HISTORIC AND DESIGN REVIEW COMMISSION

HDRC CASE NO: 2017-217
ADDRESS: 1111 E CROCKETT ST
LEGAL DESCRIPTION: NCB 578 BLK D LOT W32.83 FT OF E 65.66 FT OF 5 ARB A7 AT 1111 CROCKETT ST E
ZONING: RM-4, H
CITY COUNCIL DIST.: 2
DISTRICT: Dignowity Hill Historic District
APPLICANT: Felix Ziga/Studio Ziga
OWNER: Henneke Financial Group, LLC
TYPE OF WORK: Construction of a two story, single family residential structure
REQUEST:

The applicant is requesting a Certificate of Appropriateness for approval to construct a two story residential structure on the vacant lot at 1111 E Crockett.

EXISTING & PROPOSED EXTERIOR ELEVATIONS UNIT A

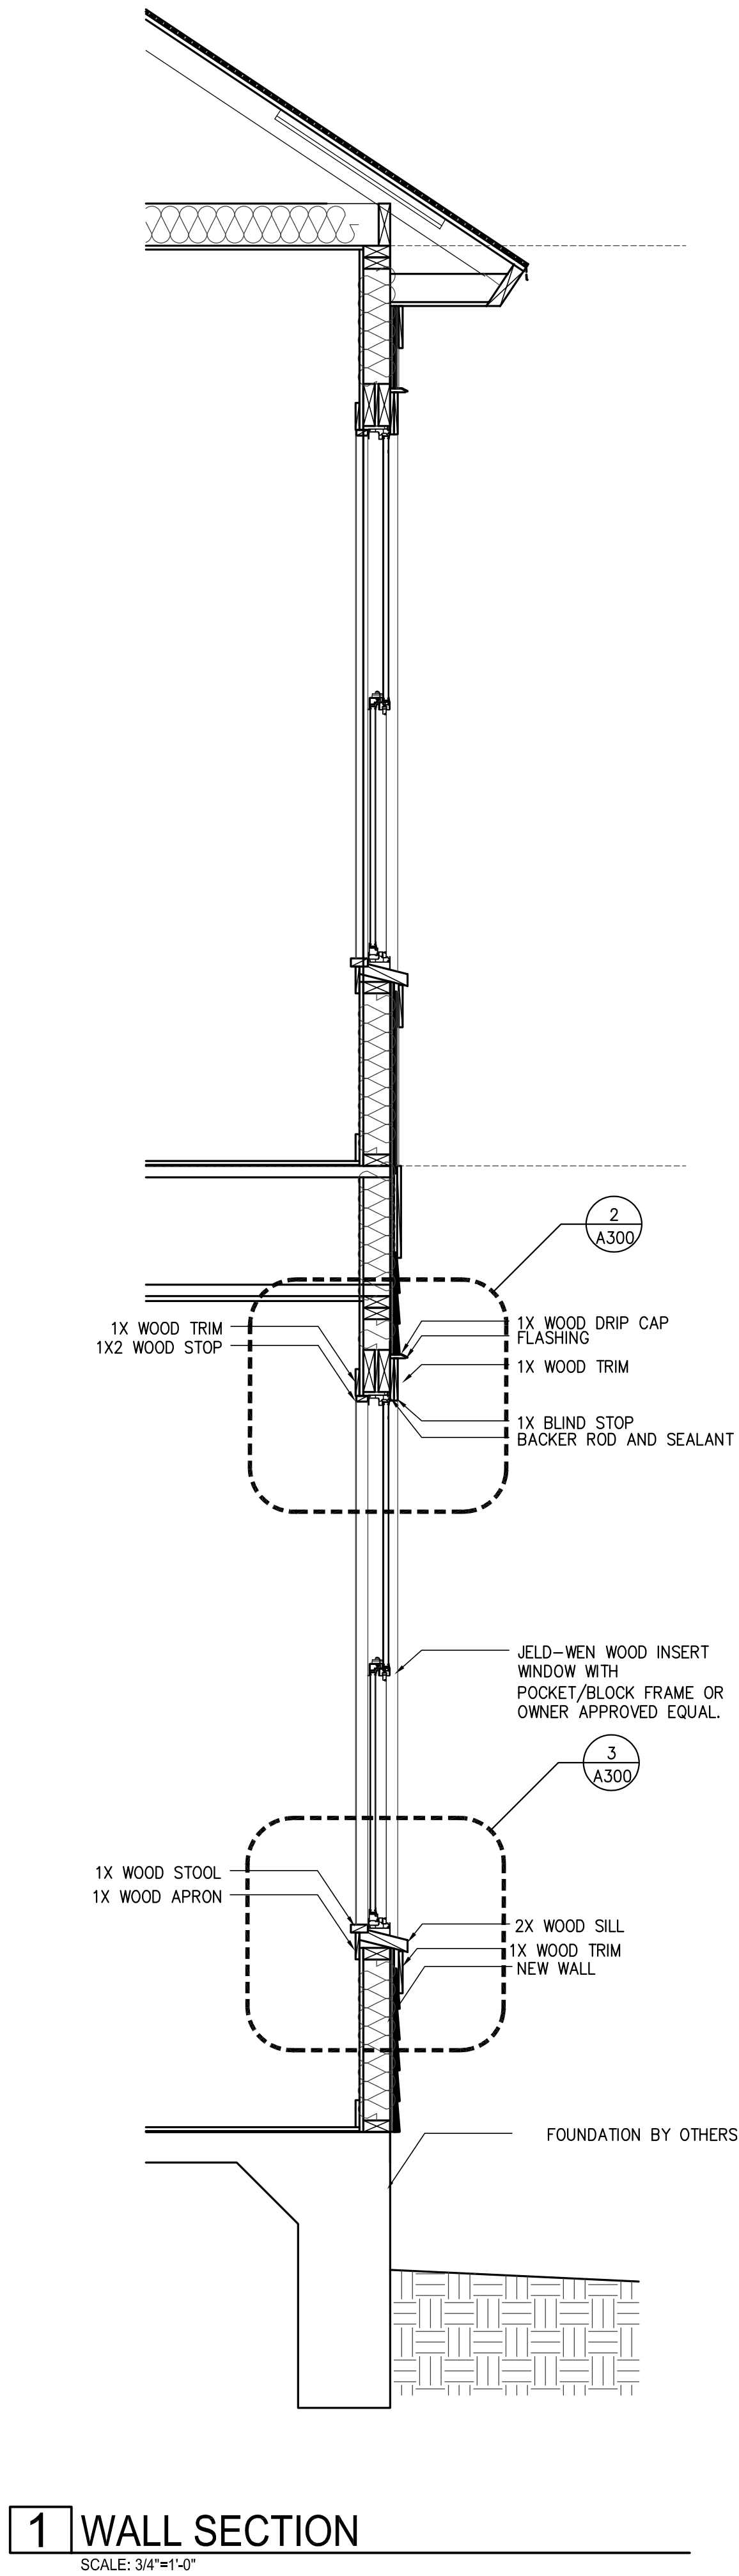
- j. WINDOW & DOOR OPENINGS – The applicant has proposed a small fixed window on the front façade that is located in an upstairs bathroom. Staff finds that this window should be a sash window like other similarly sized windows.

- o. COLUMN DESIGN – The applicant has proposed eight in square cedar columns. Given the proposed height and porch massing, staff finds the proposed columns to feature an appropriate size; however, each column should feature both a capital and base.

- ii. That the proposed front yard fencing does not exceed four (4) feet in height as noted in finding t.
- iii. That the applicant install a sash window in the upstairs bathroom on the front façade as noted in finding j.

WALL SECTION AND DETAILS

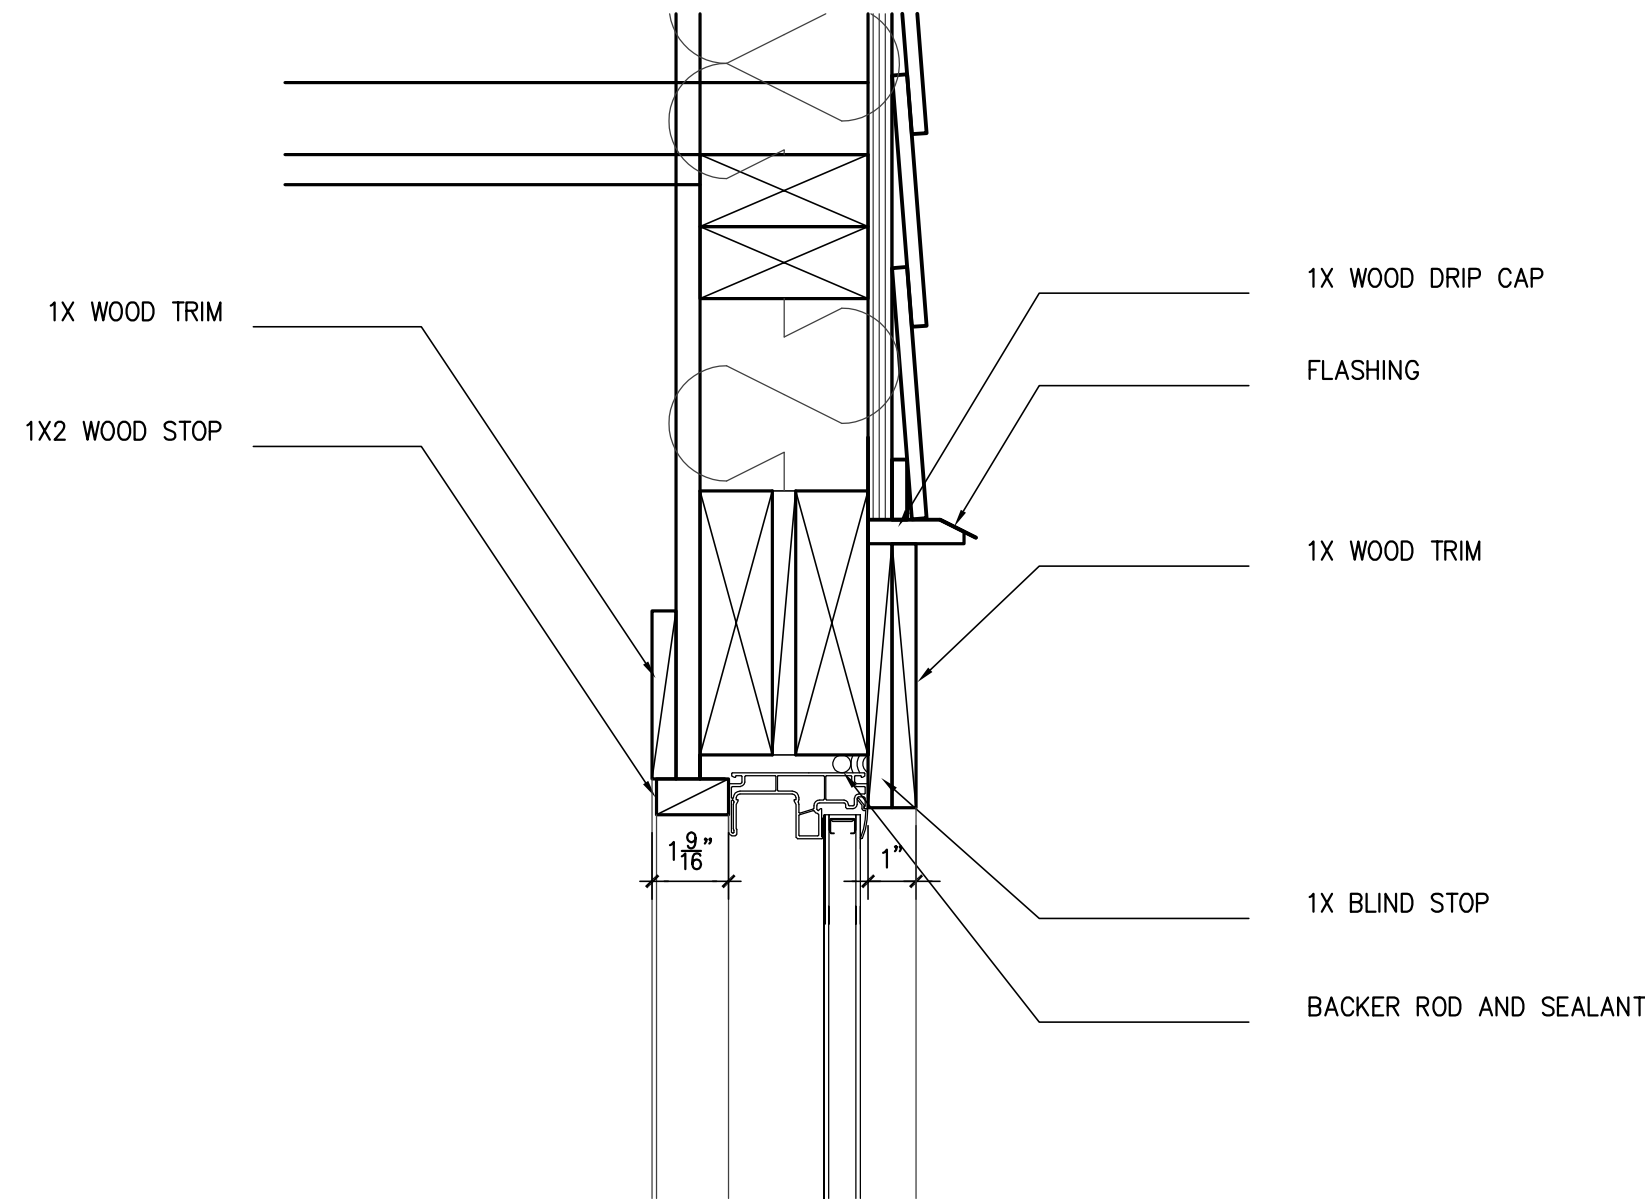
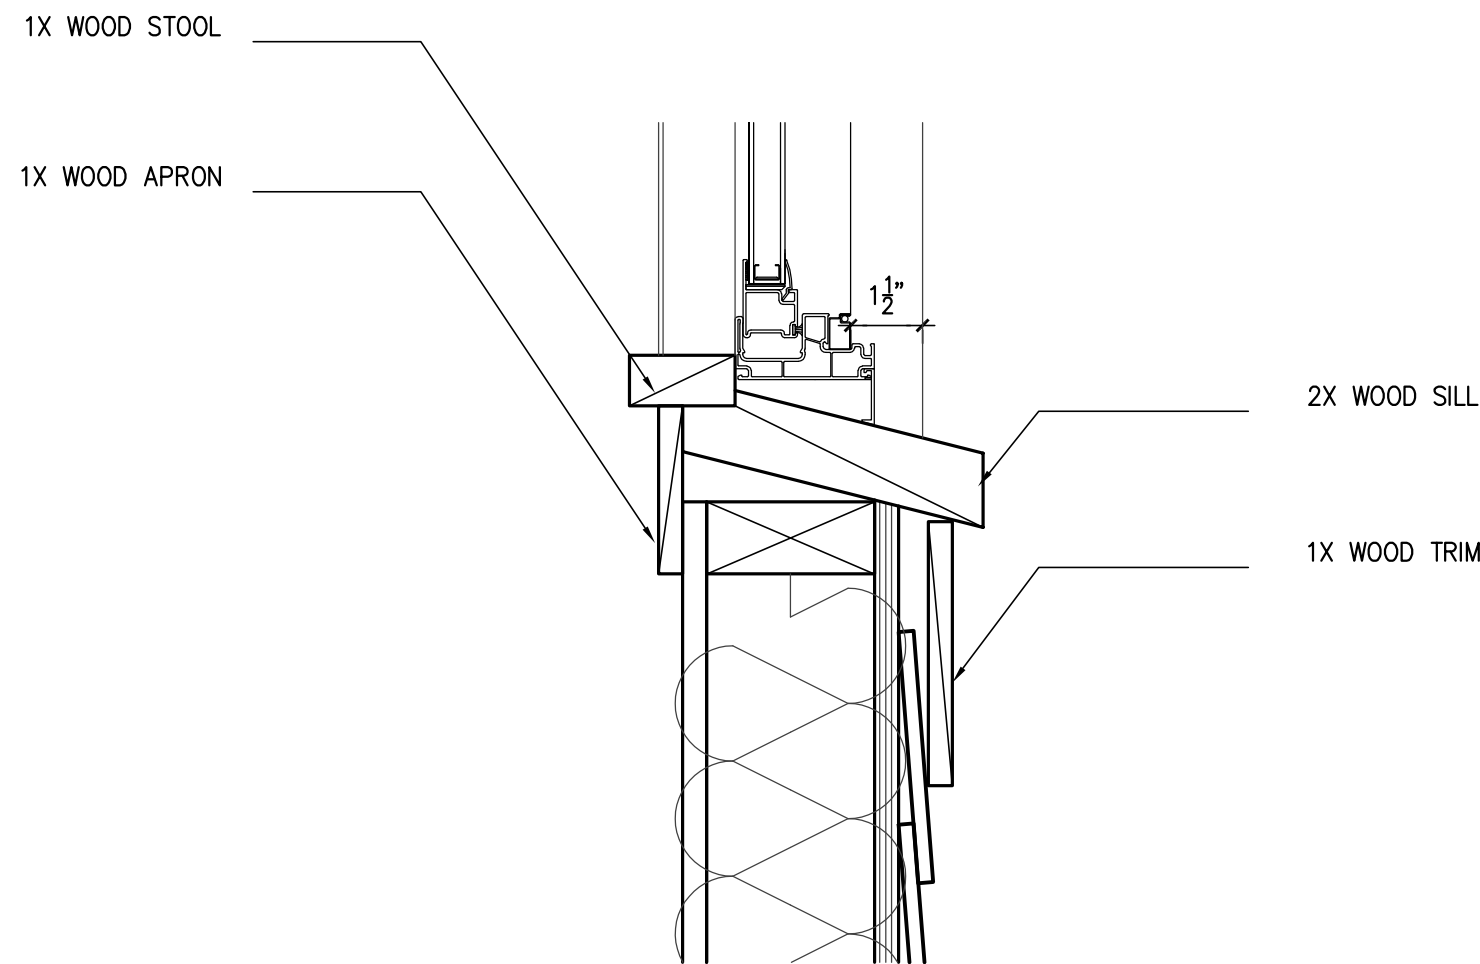
- m. WINDOW MATERIALS – The applicant has proposed block framed vinyl windows. The applicant has provided staff with a wall section noting an installation depth of one inch. Staff finds that the applicant should provide additional product information for the windows including a product specification sheet that notes window sash profiles, consistency with historic window profiles, colors and track colors.

- i. That the applicant provide additional product information for the windows including a product specification sheet that notes window sash profiles, consistency with historic window profiles, colors and track colors for approval by staff as noted in finding m.
